VERMONT YANKEE NUCLEAR POWER STATION

Amendment No. 79
License No. DPR-28

ATTACHMENT TO LICENSE AMENDMENT NO. 79

SAFETY EVALUATION BY THE OFFICE OF NUCLEAR REACTOR REGULATION
SUPPORTING AMENDMENT NO. 79 TO FACILITY OPERATING LICENSE NO. DPR-28
VERMONT YANKEE NUCLEAR POWER CORPORATION
VERMONT YANKEE NUCLEAR POWER STATION
DOCKET NO. 50-271

ORGANIZATIONAL CHART
FIGURE 6.1.2

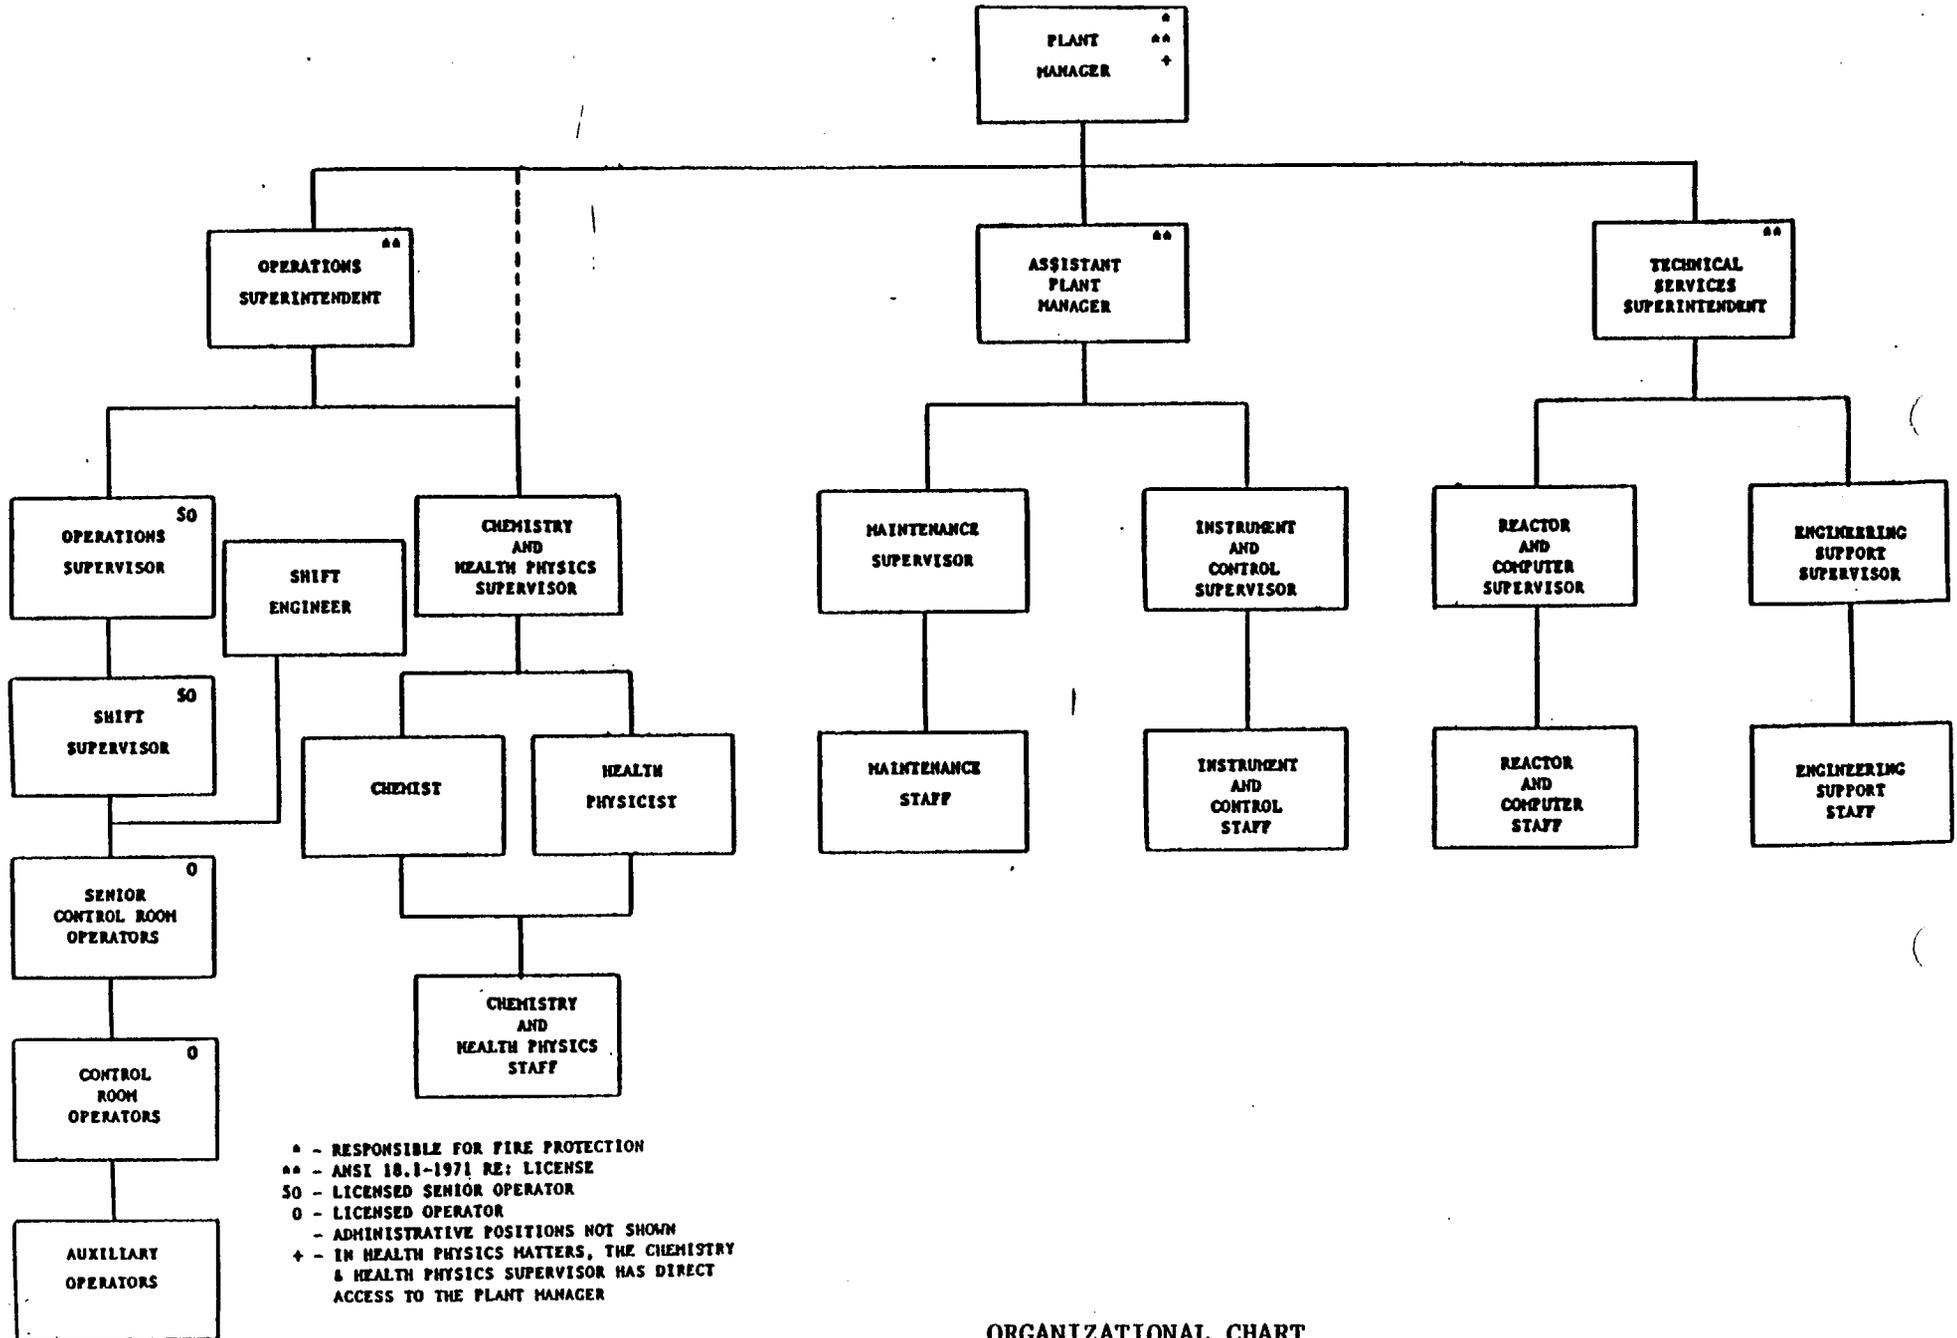
In the existing Technical Specifications for the Vermont Yankee plant, the individuals providing engineering advice to the operating shift are designated the Shift Technical Advisors. By this change, the licensee proposes to change the title to Shift Engineer. This is a title change only and would have no effect on the qualifications or performance of these individuals. Hence, approving the change would have no adverse effect on the health and safety of the public.

In the existing plant organization, the Shift Technical Advisors report to the Technical Services Superintendent. Under the proposed change, the Shift Engineers will be located in the Operations Department.

The licensee now has eight individuals trained for STA duties. Under the proposed organizational change, one Shift Engineer would be assigned as an integral member of each of the six operating shifts. These individuals would rotate with their shifts, including taking requalification training during the training week. While on shift, the Shift Engineer will work for the Shift Supervisor, performing non-licensed duties as assigned. These duties include a primary function of providing advice and assistance to the Shift Supervisor on any off-normal events that may occur, and normally would also include such matters as handling work permits involving possible fire hazards and preparing plant information reports.

Based on the discussion presented above, we conclude that Proposed Change No. 112 to the Vermont Yankee Technical Specification is acceptable.
